SERVICE MANUAL

Matrix-12

ENGINEERING CHANGE ORDER

PRODUCT AFFECTED	MATRIX-12	DRAWINGS/ASSEMBLY AFFECTED	Matrix -12 Rev. D Upper and Lower Voice Board (Ass'y #1810D / Part No. 720103)	ECO NUMBER	805
EFFECTIVITY	REASON FOR CHANGE				
☐ AS REQUIRED IN TEST ☒ FUTURE PRODUCTION ☐ RETROFIT PRODUCTION & INVENTORY ☒ RETROFIT IN FIELD ☒ AS NEEDED ☐ DRAWING CORRECTION ONLY ☐ PARTS PURCHASING	Software update, version CA 1.6. Eliminate the possibility of the CA Voice software from mis-reading the Voice Board revision on power up.				
ECO #805 - Part No. 950072

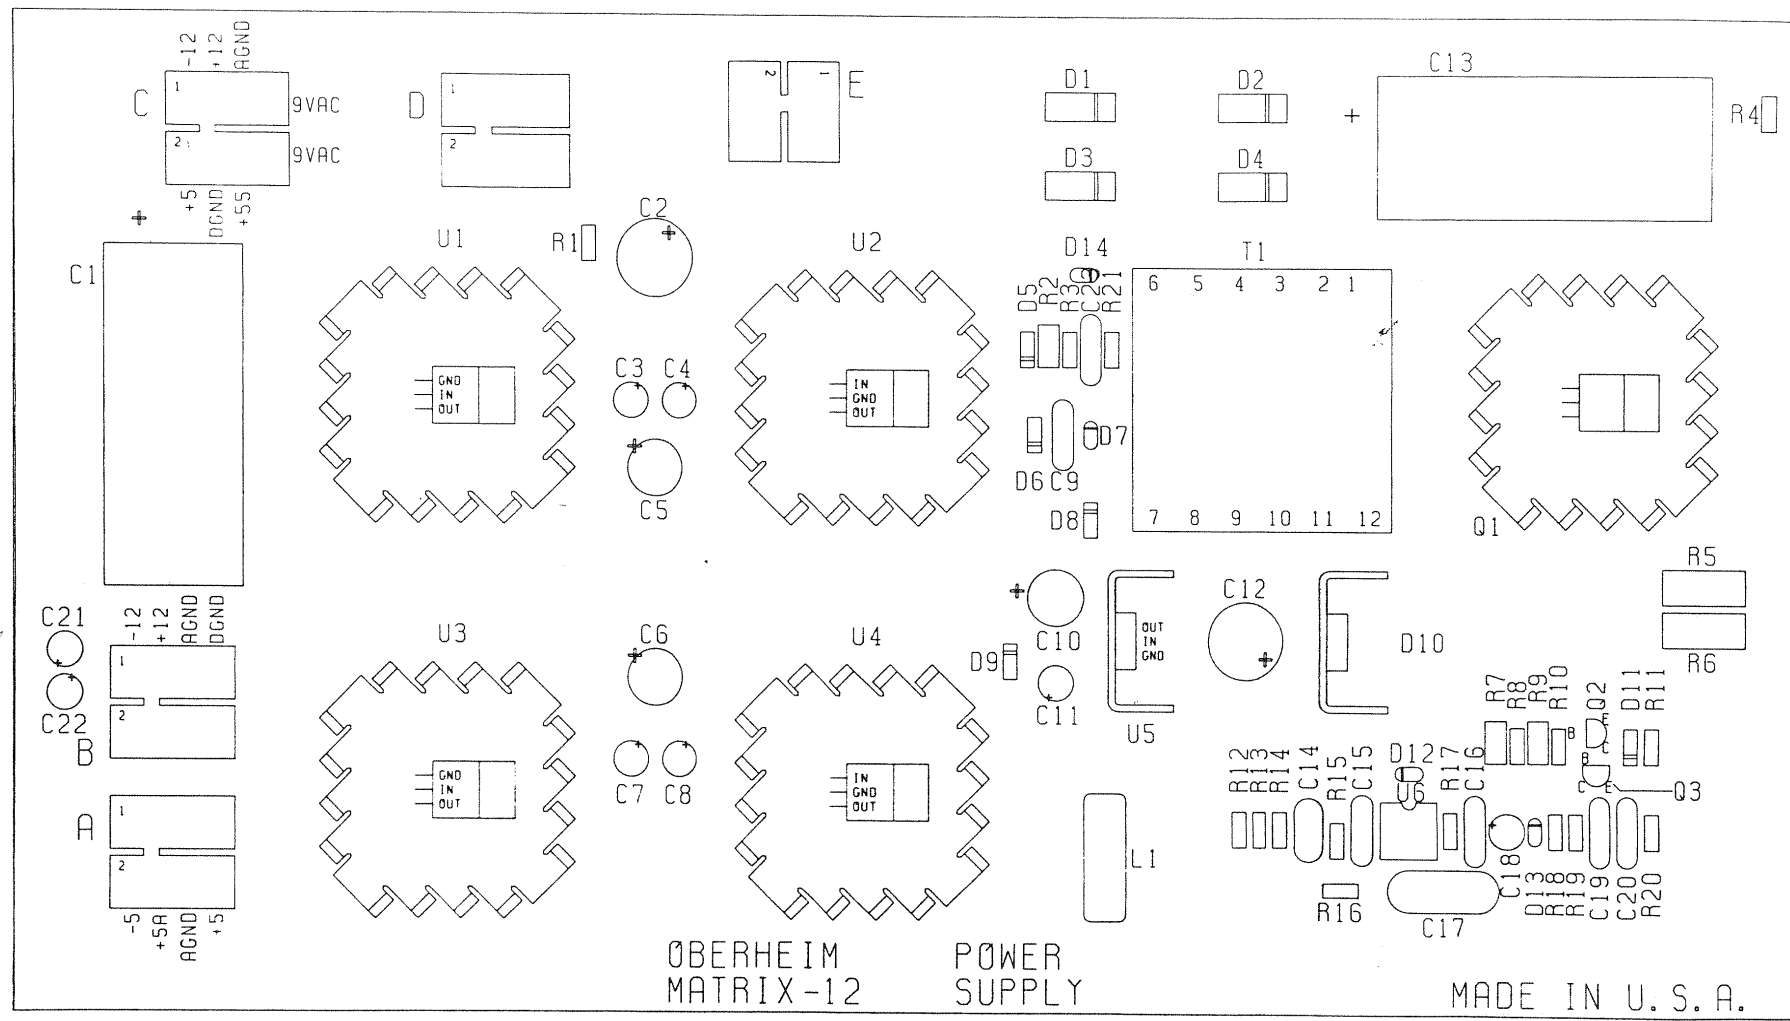
TO ELIMINATE THE POSSIBILITY OF THE CLOCK CABLES BECOMING DISCONNECTED FROM THE PROCESSOR BOARD WHILE IN TRANSIT.

1. MODIFY TWO CABLE ASSEMBLIES #4 (OBERHEIM PART #750185-0) BY REMOVING ONE OF THE TWO 3 PIN MOLEX CONNECTORS ON EACH SO THAT THERE IS A CONNECTOR ON ONLY ONE END OF EACH CABLE.
2. REMOVE THE 3 PIN MALE MOLEX CONNECTORS (OBERHEIM PART #219340) ON THE MATRIX-12 PROCESSOR BOARD (720102) AT CONNECTOR LOCATIONS D AND E.
3. SOLDER THE BARE WIRE END OF CABLE ASSEMBLIES TO THE PROCESSOR BOARD AT LOCATIONS D AND E. THE SHIELD OF ONE OF THE CABLES SHOULD BE SOLDERED TO PIN 1 OF CONNECTOR D, AND THE CENTER CONDUCTOR OF THE SAME CABLE SHOULD BE SOLDERED TO PIN 2 OF CONNECTOR D. THE OTHER CABLE SHOULD BE CONNECTED IN THE SAME MANNER TO CONNECTOR E.
